Beaver Valley Power Station
Unit Nos. 1 and 2

License Amendment Requests
302 and 173

Extended Power Uprate

Subject: Beaver Valley Power Station, Unit No. 1 and No. 2
BV-1 Docket No. 50-334, License No. DPR-66
BV-2 Docket No. 50-412, License No. NPF-73
License Amendment Request Nos. 302 and 173

Figure 4.2-2
Reactor Coolant System Cooldown (up to 0°F/Hr.)
Limitations Applicable for the First ~~14~~22 EFPY (TS 3.4.9.1)

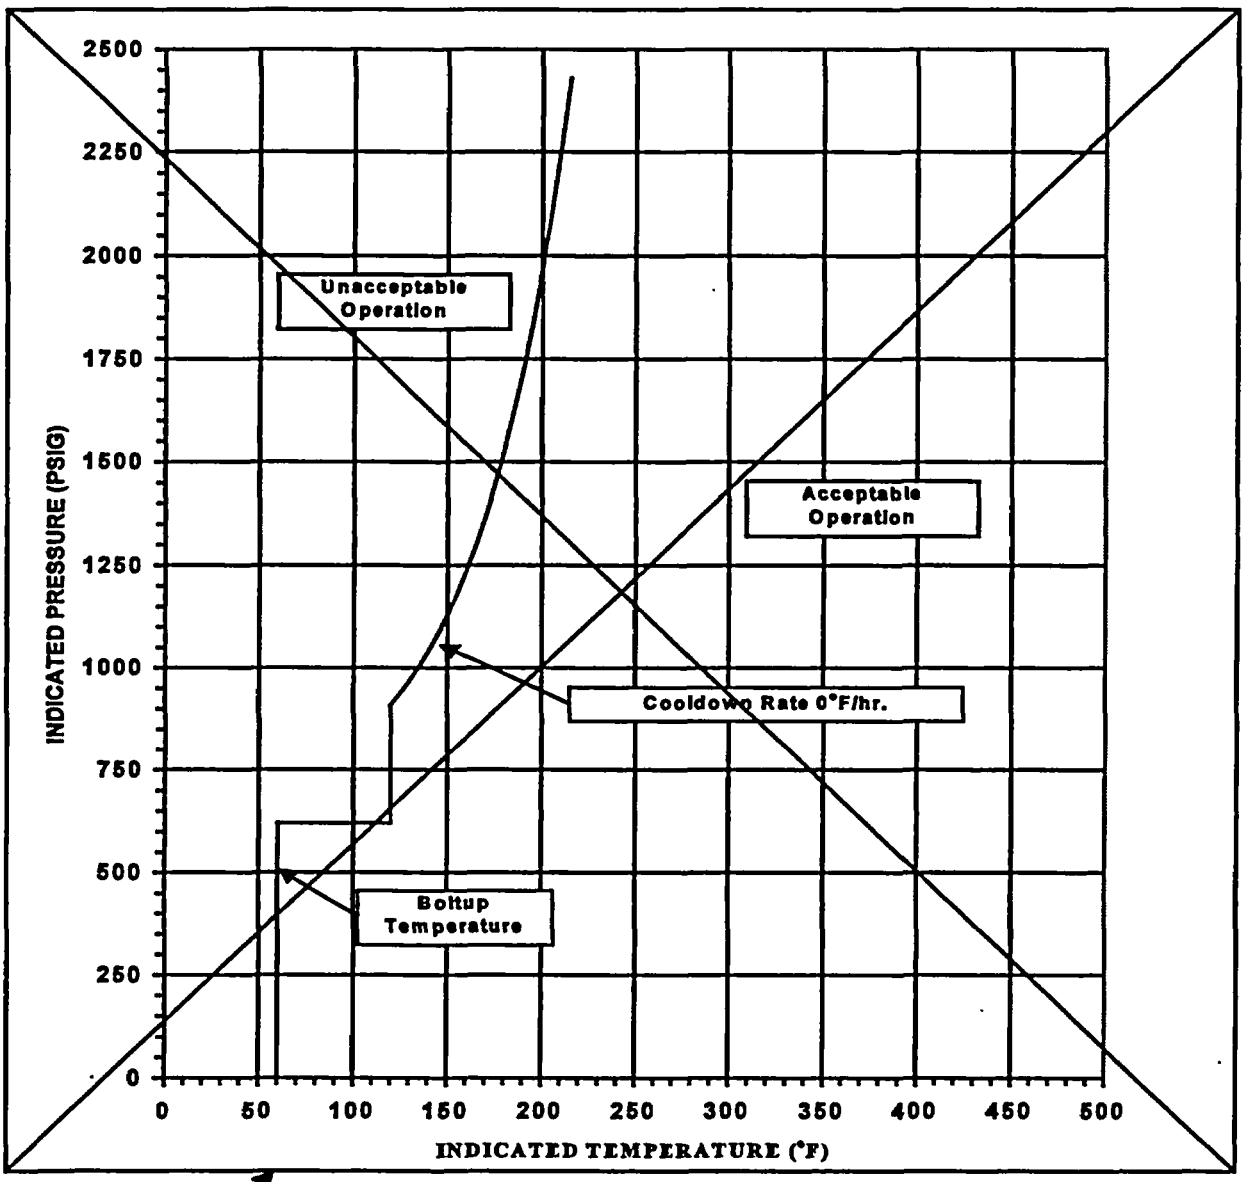
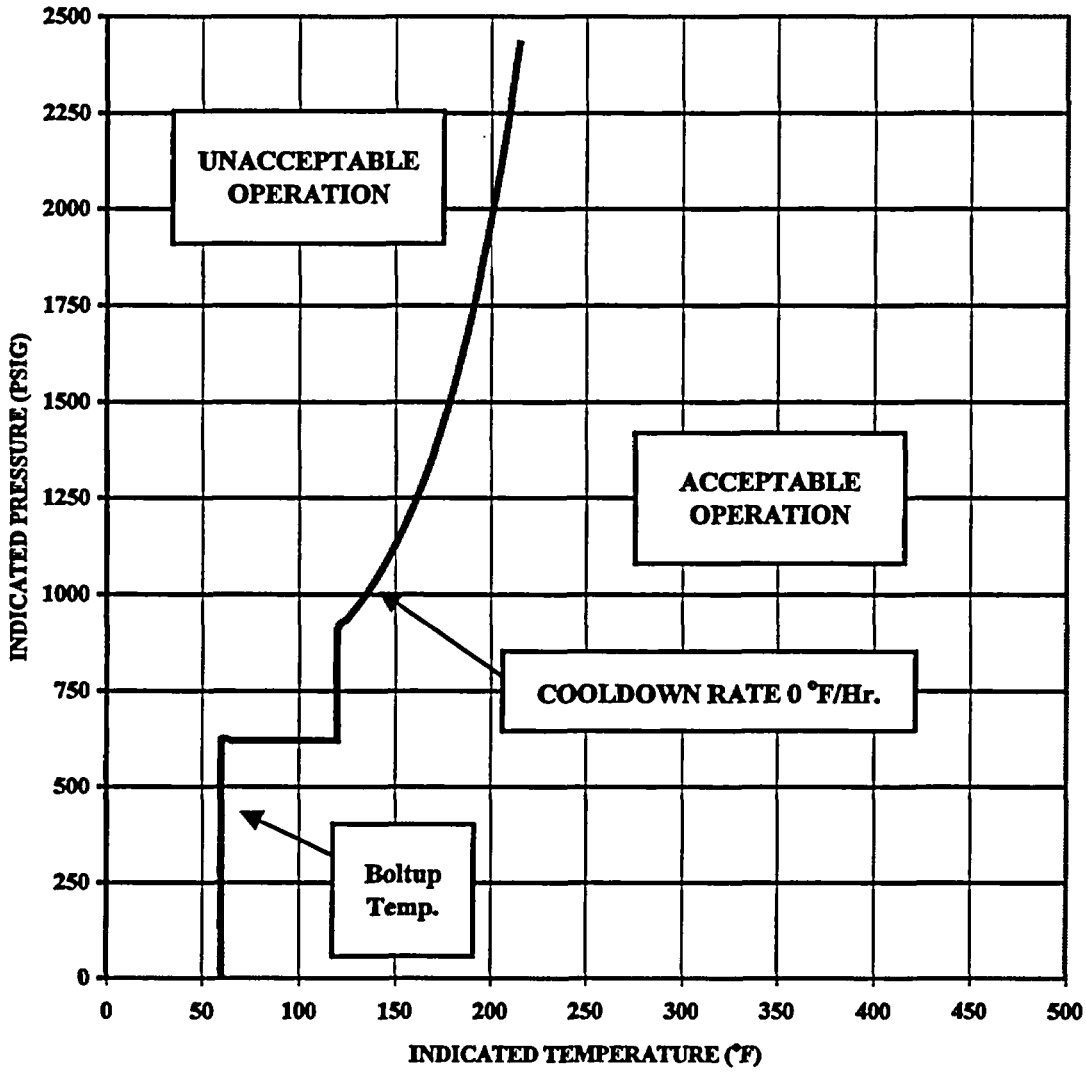
CONTROLLING MATERIAL:	INTERMEDIATE SHELL PLATE B9004-1
INITIAL RT_{NDT}:	60°F
RT_{NDT} AFTER ~~14~~22 EFPY:	1/4T, 140°F
	3/4T, ~~128~~129°F

Replace with Insert C2-5.

Insert C2-5.

Figure 4.2-3
Reactor Coolant System Cooldown (up to 20°F/Hr.)
Limitations Applicable for the First ~~14~~22 EFPY (TS 3.4.9.1)

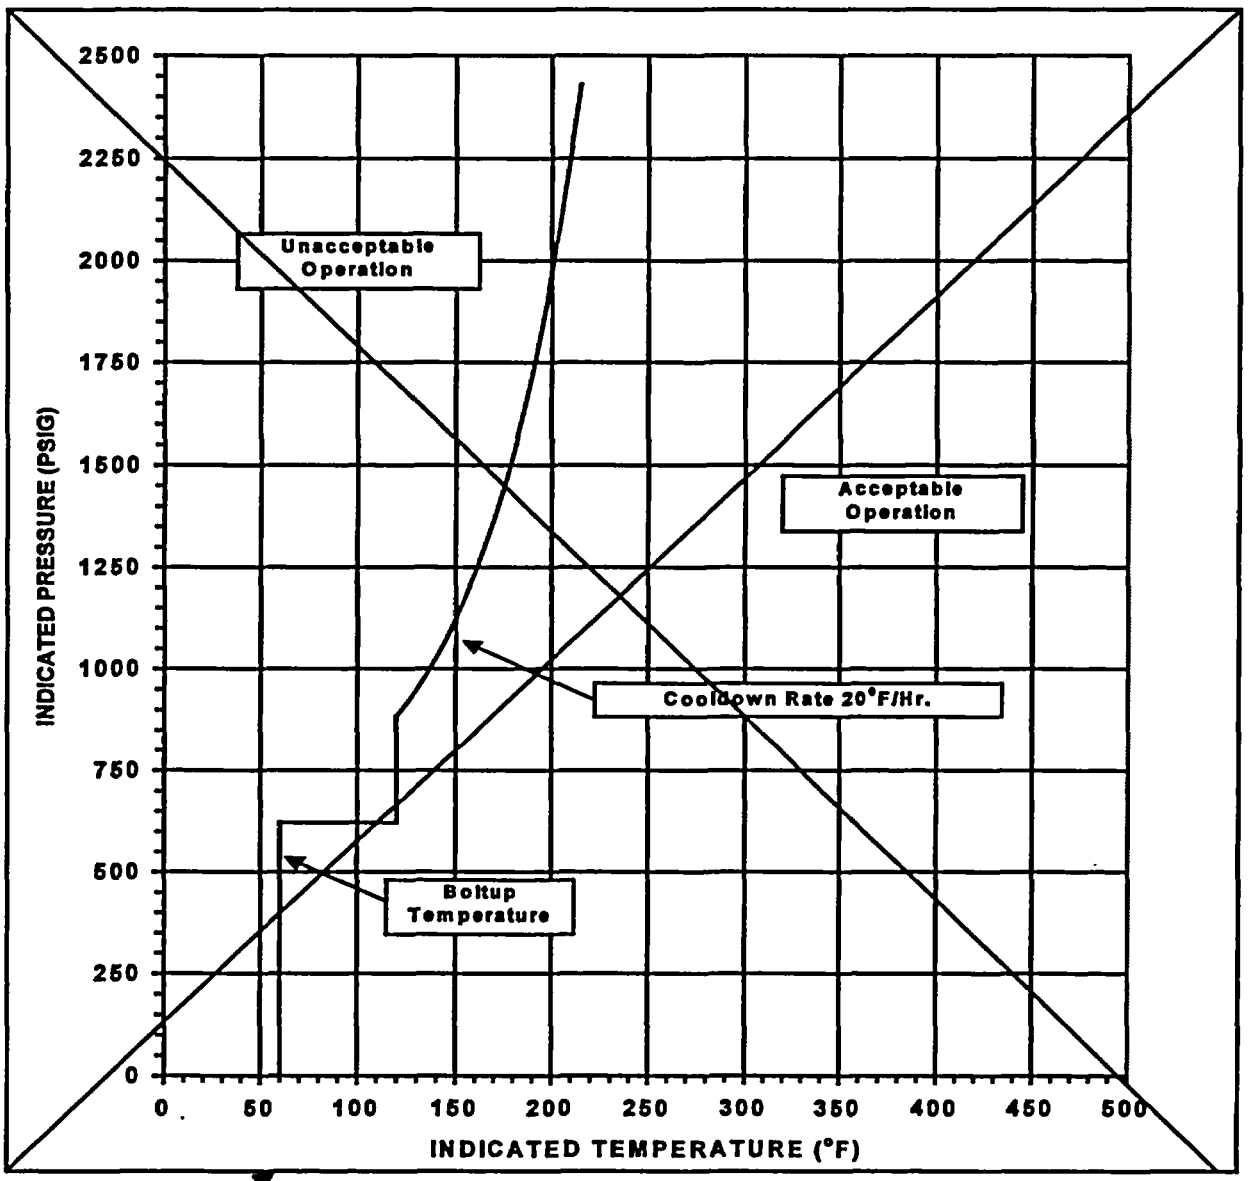
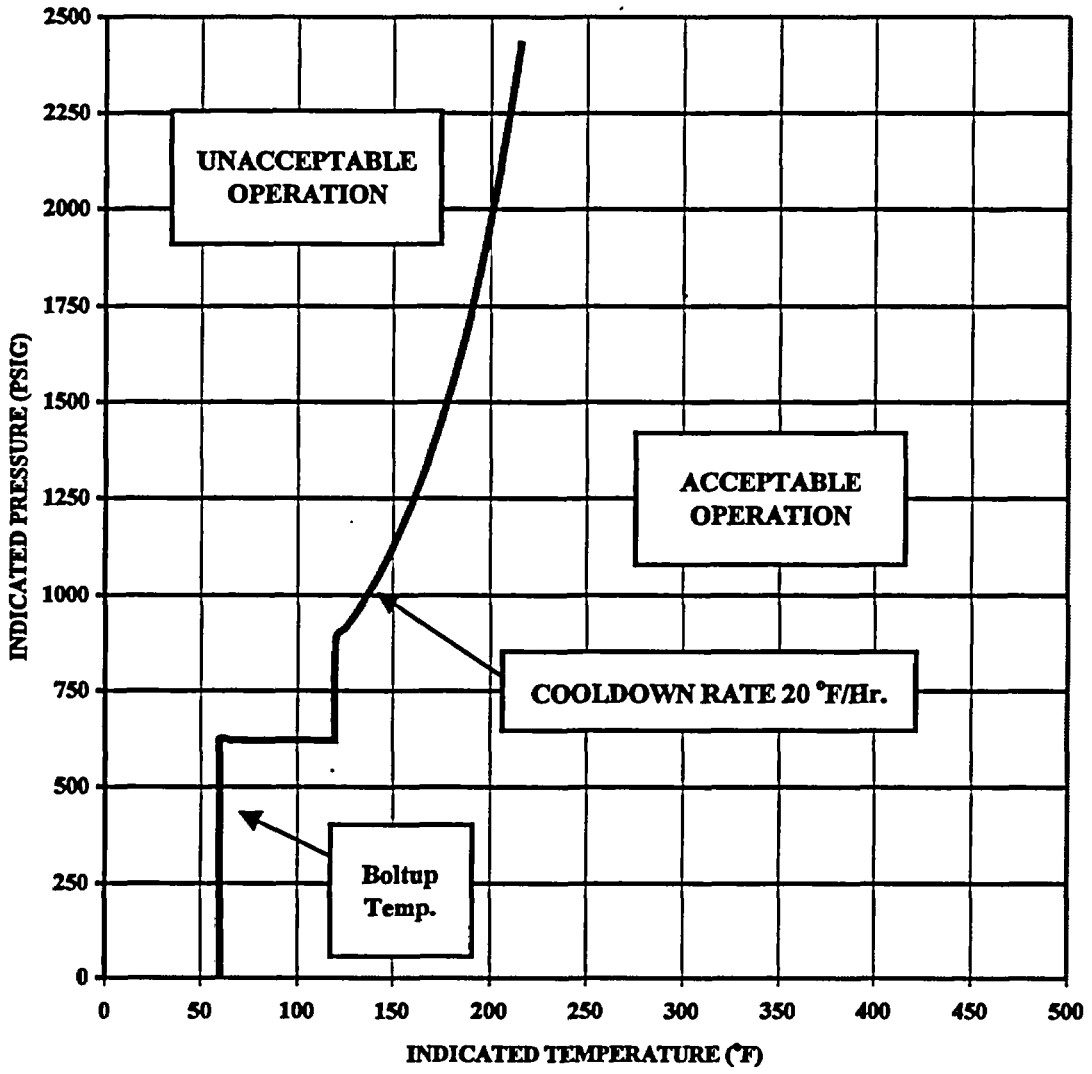
CONTROLLING MATERIAL:	INTERMEDIATE SHELL PLATE B9004-1
INITIAL RT_{NDT}:	60°F
RT_{NDT} AFTER ~~14~~22 EFPY:	1/4T, 140°F
	3/4T, ~~128~~129°F

Replace with Insert C2-6.

Insert C2-6.

Figure 4.2-4
Reactor Coolant System Cooldown (up to 40°F/Hr.)
Limitations Applicable for the First ~~14~~22 EFPY (TS 3.4.9.1)

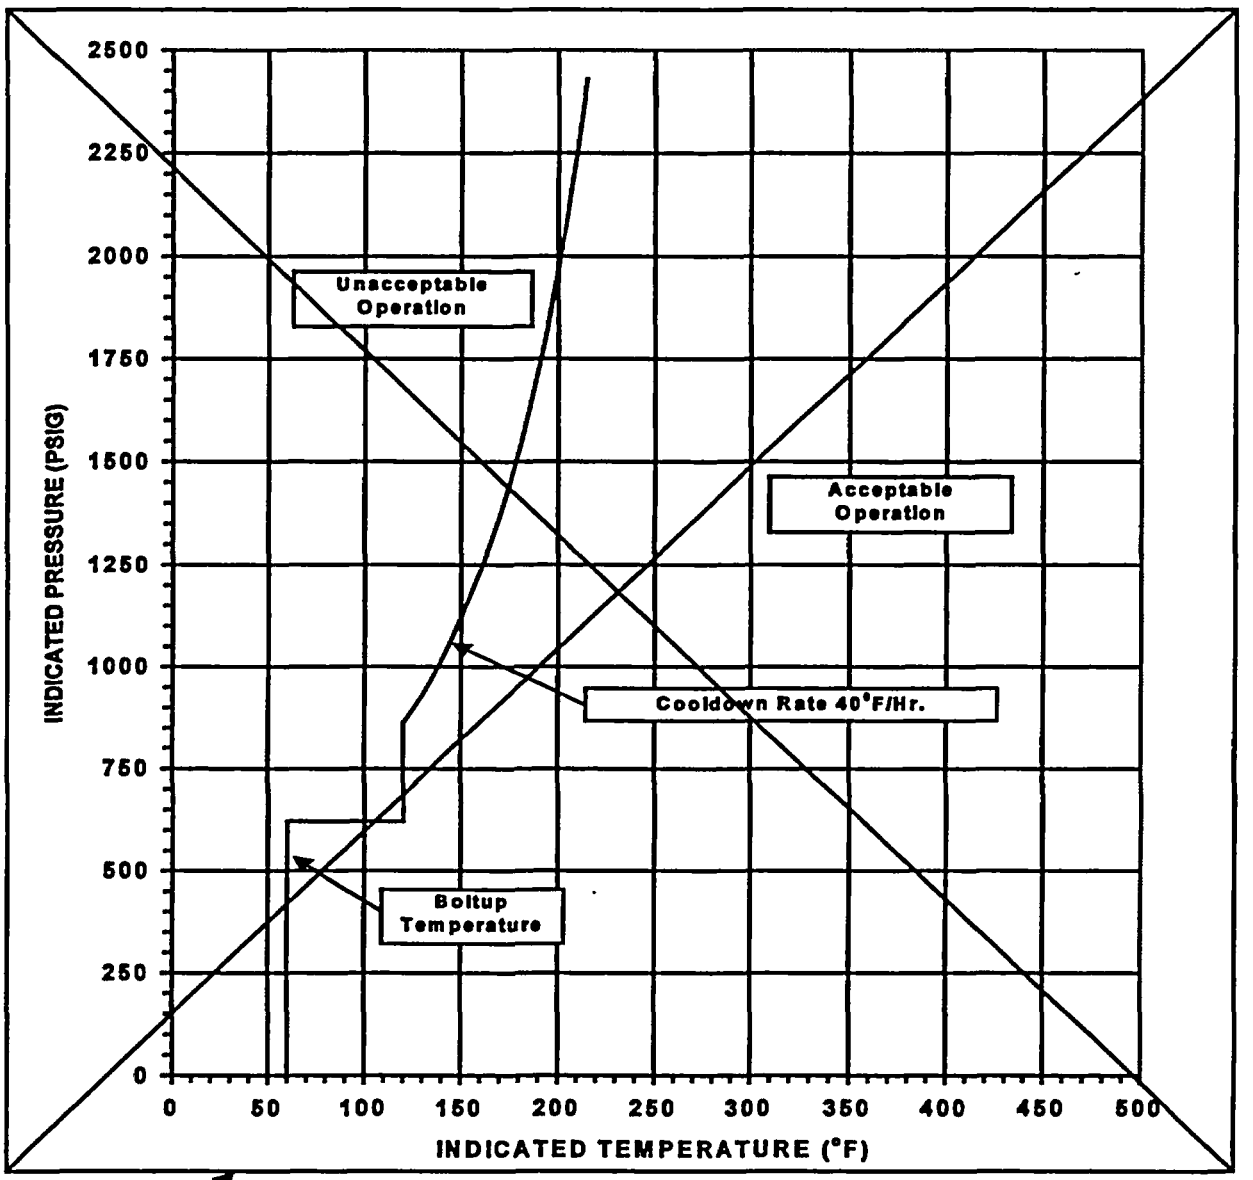
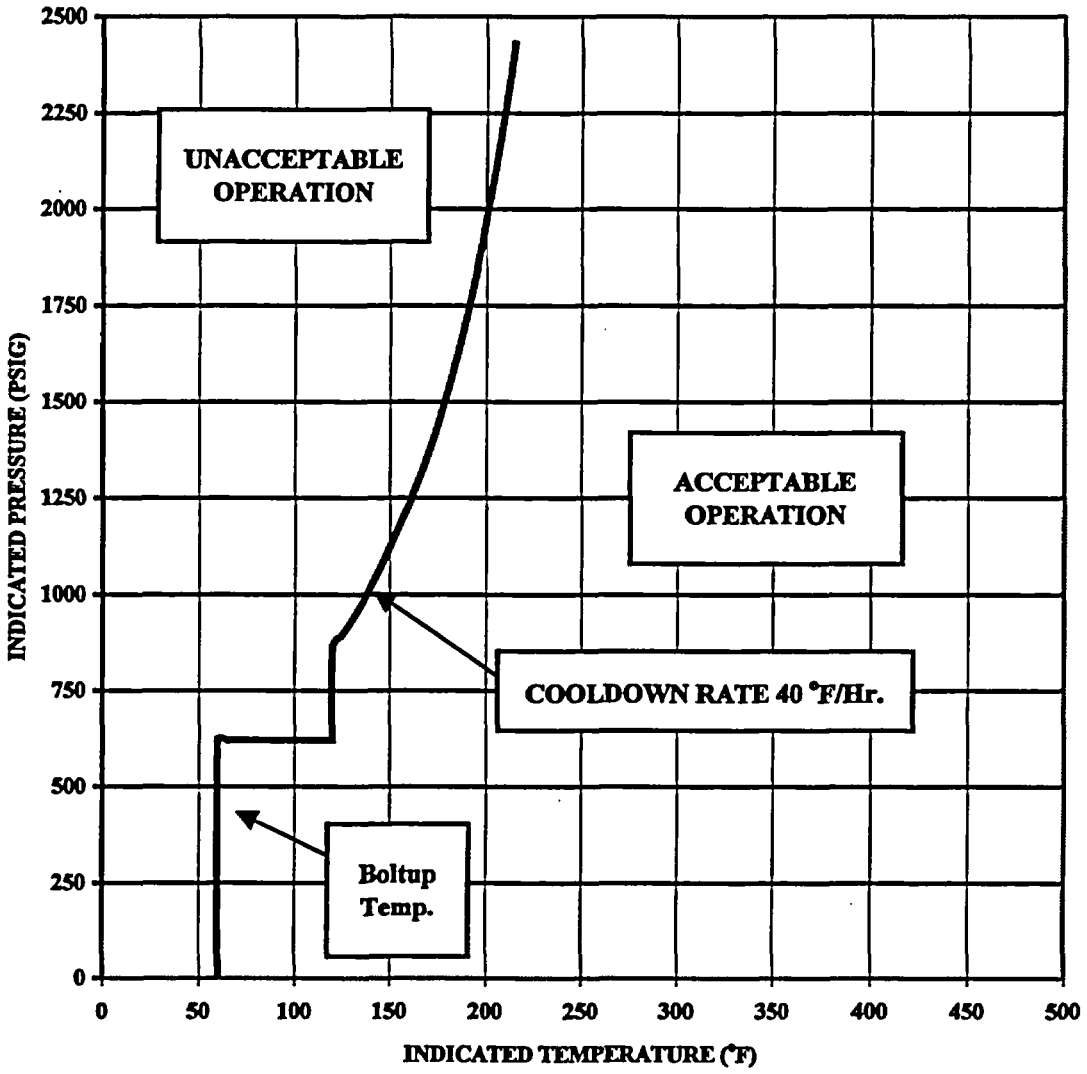
CONTROLLING MATERIAL:	INTERMEDIATE SHELL PLATE B9004-1
INITIAL RT_{NDT}:	60°F
RT_{NDT} AFTER ~~14~~22 EFPY:	1/4T, 140°F
	3/4T, ~~128~~129°F

Replace with Insert C2-7.

Insert C2-7.

Figure 4.2-5
Reactor Coolant System Cooldown (up to 60°F/Hr.)
Limitations Applicable for the First ~~14~~22 EFPY (TS 3.4.9.1)

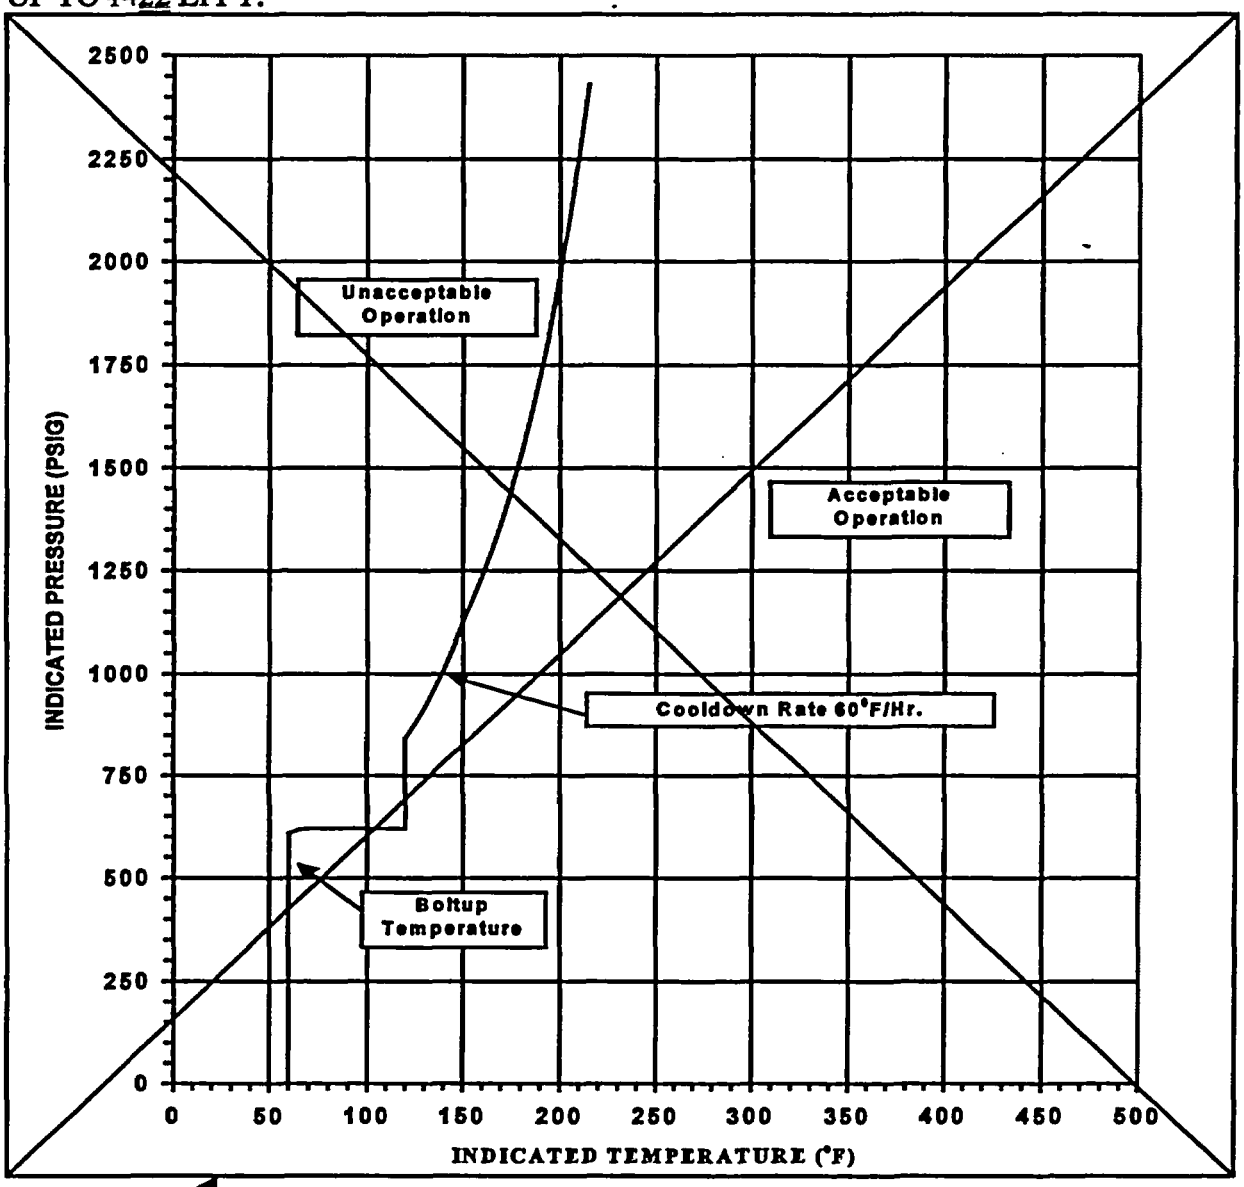
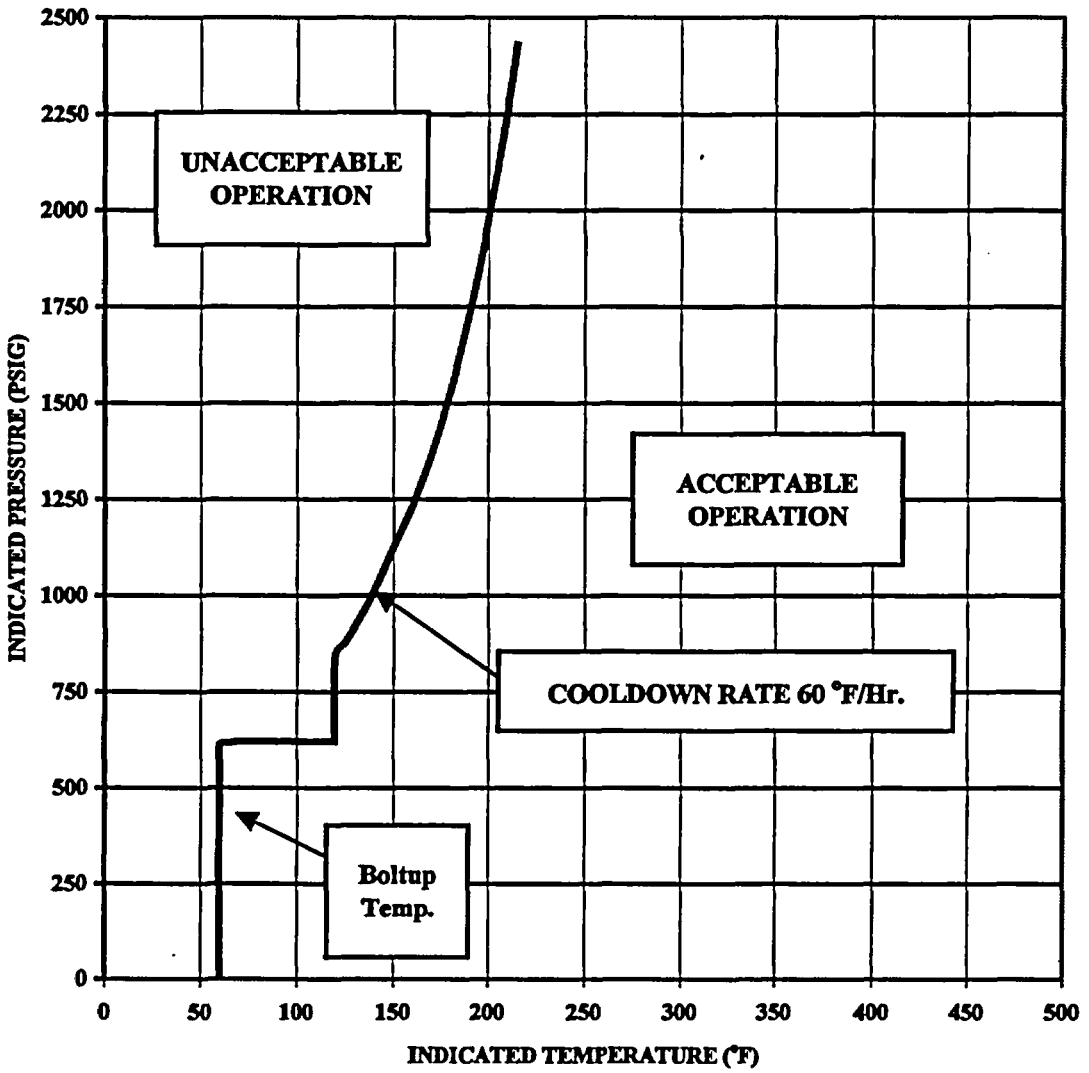
CONTROLLING MATERIAL:	INTERMEDIATE SHELL PLATE B9004-1
INITIAL RT_{NDT}:	60°F
RT_{NDT} AFTER ~~14~~22 EFPY:	1/4T, 140°F
	3/4T, ~~128~~129°F

Replace with Insert C2-8.

Insert C2-8.
